The European consumer voice in standardisation

60th informal group on ECRS, 12 September 2016

Some findings in recent testing of R44 approved CRS.

Do we want to encourage such solutions in R129 approved ECRS?

One size fits all: Group 0/1/2/3 CRS

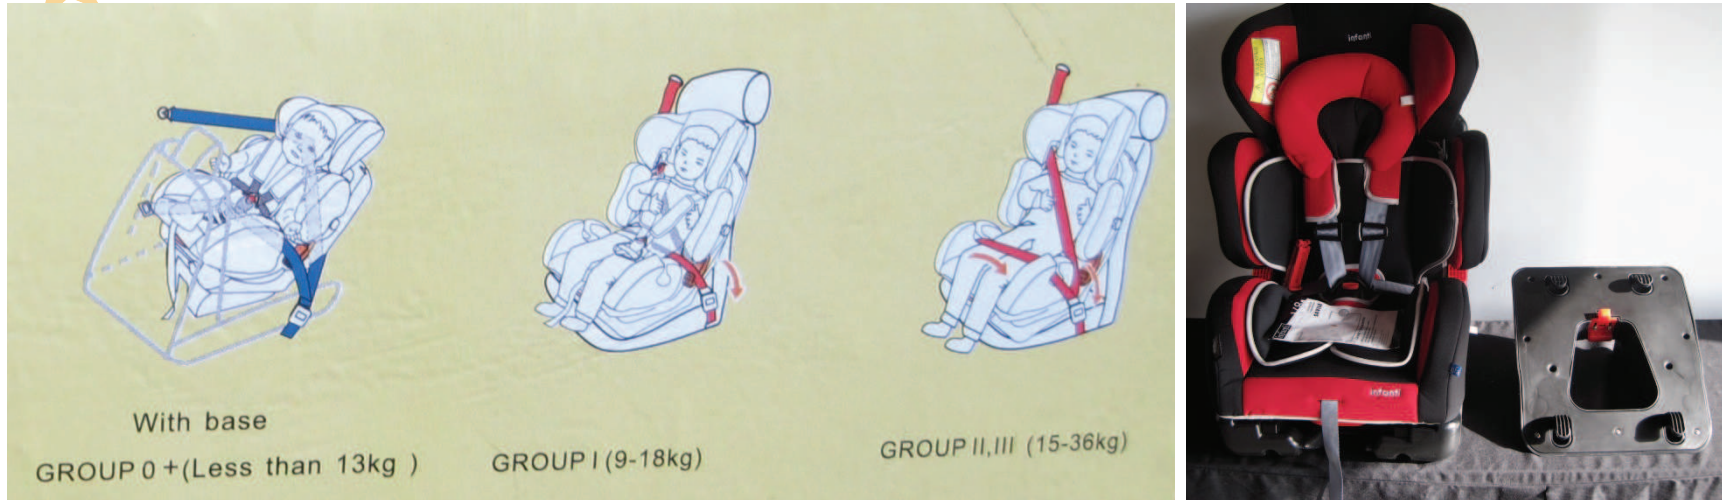
- Misuse risk:
 - Several installation modes, applying loose part (wedge) and two different red coloured belt routes
 - Not straightforward belt routes
- Bulky

Suggest for R129:

- *Allow only one red and one blue belt route*
- *No 'kits'*

Loose belt clips

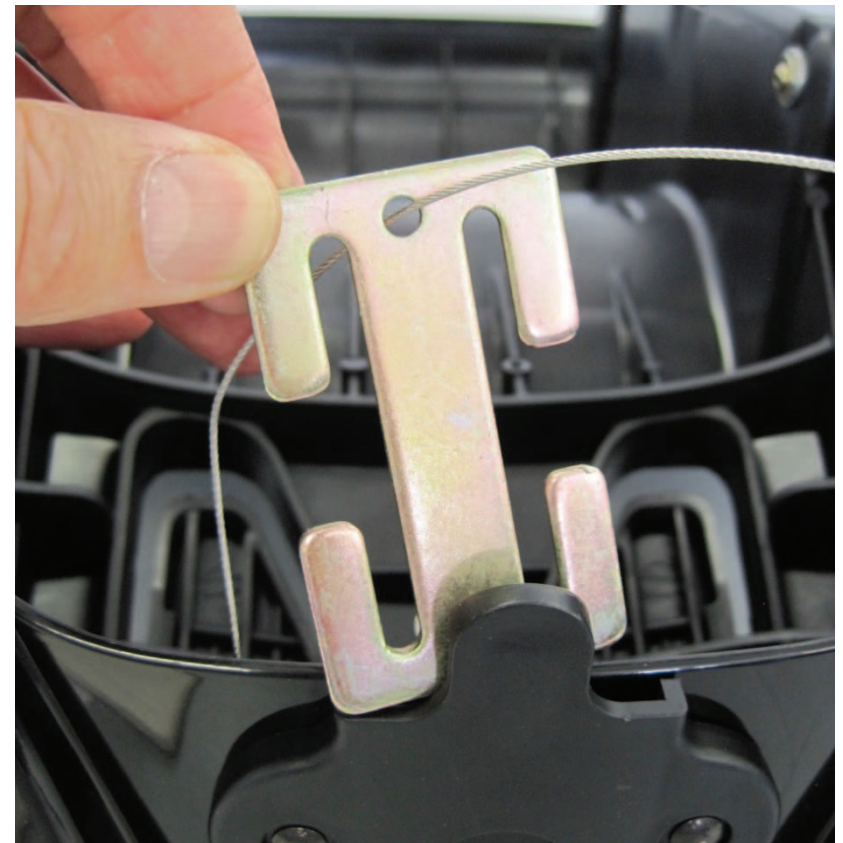
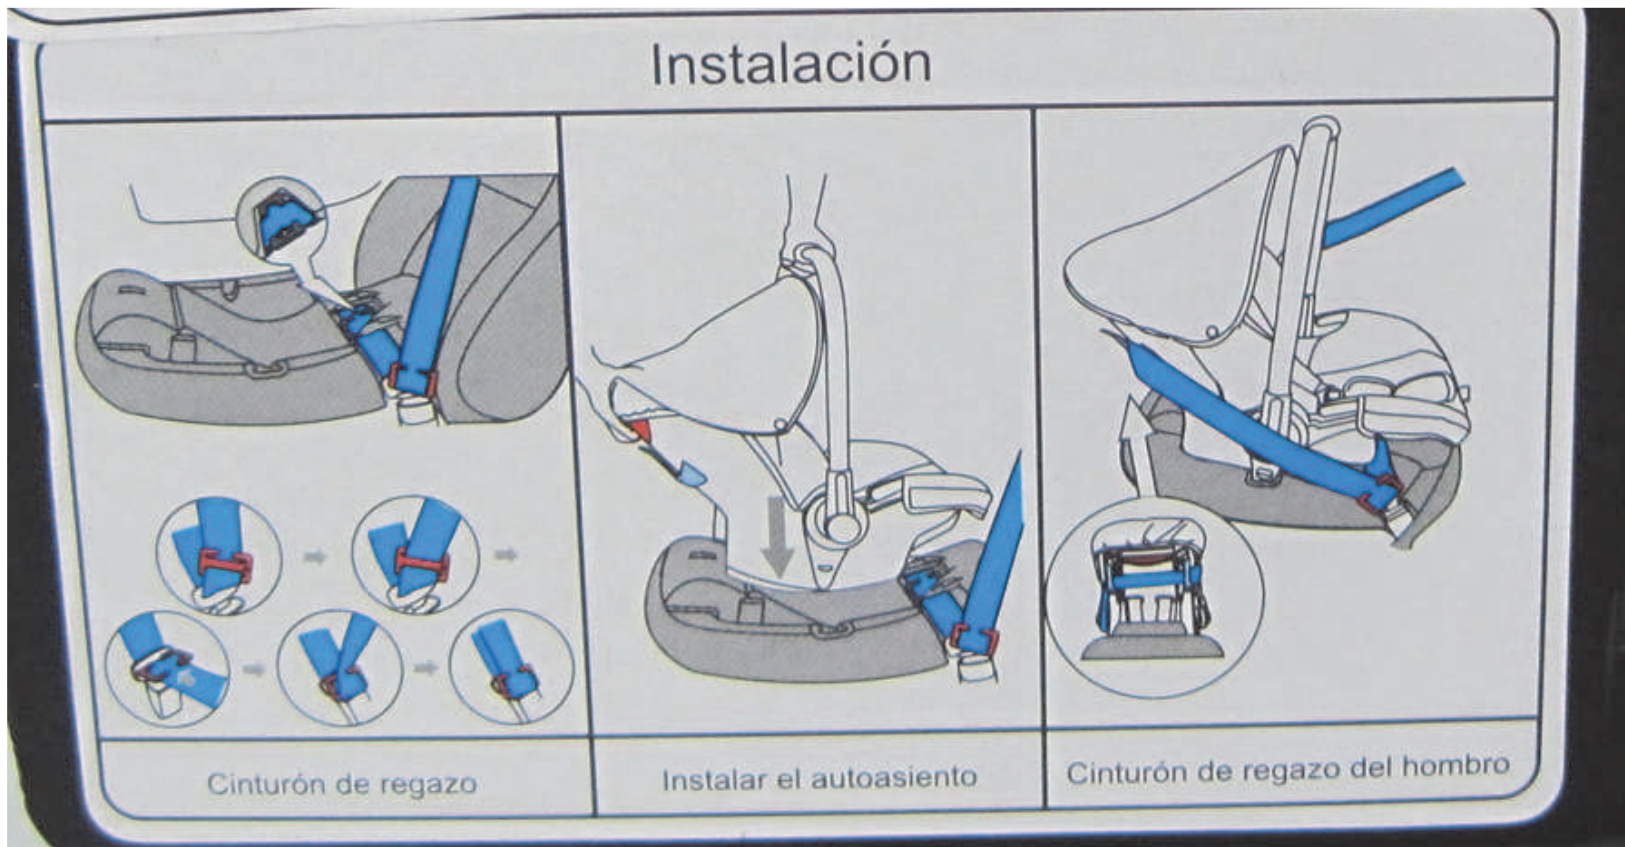
Likely to be cut off / not used.

Suggest for R129:

- *not allow non-integrated belt clips.*

Kit

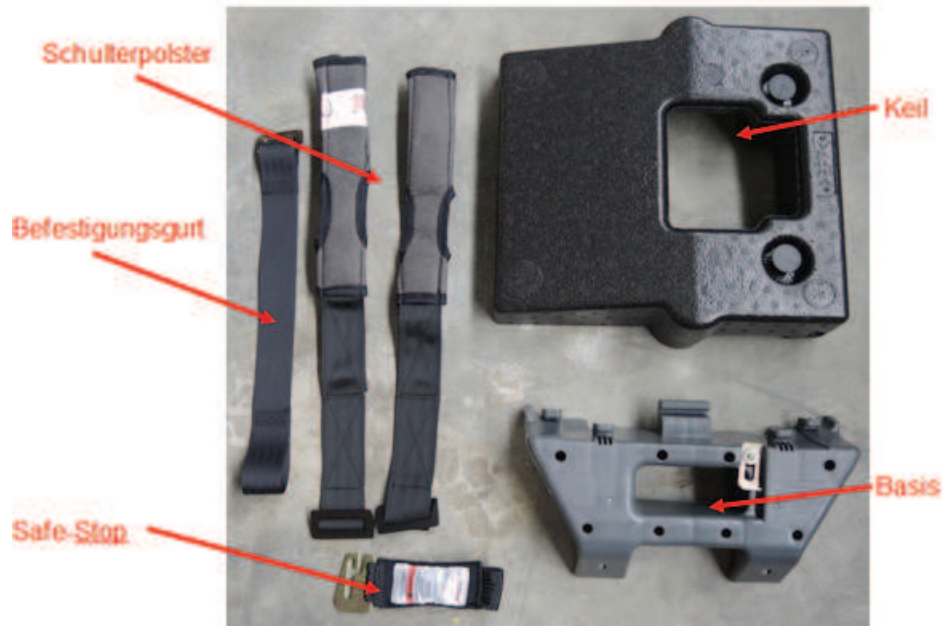
- RWF:
 - <18kg: car seat belt
 - <25kg: plus extra fixing belt
- FWF: 9-25kg,
 - 9-18kg: car seat belt
 - 9-25kg: plus Top Tether

- For RWF base ('Basis') and wedge ('Keil') must be attached .
- For kids 15 -25kg shoulder pads must be replaced by longer rubber shoulder pads ('Schulterpolster')
- RWF installation with fixing belt ('Befestigungsgurt') requires car front seat to attach.
- For FWF for kids 15-25 kg a 'Safe Stop' (load limiter) must be installed in the harness.
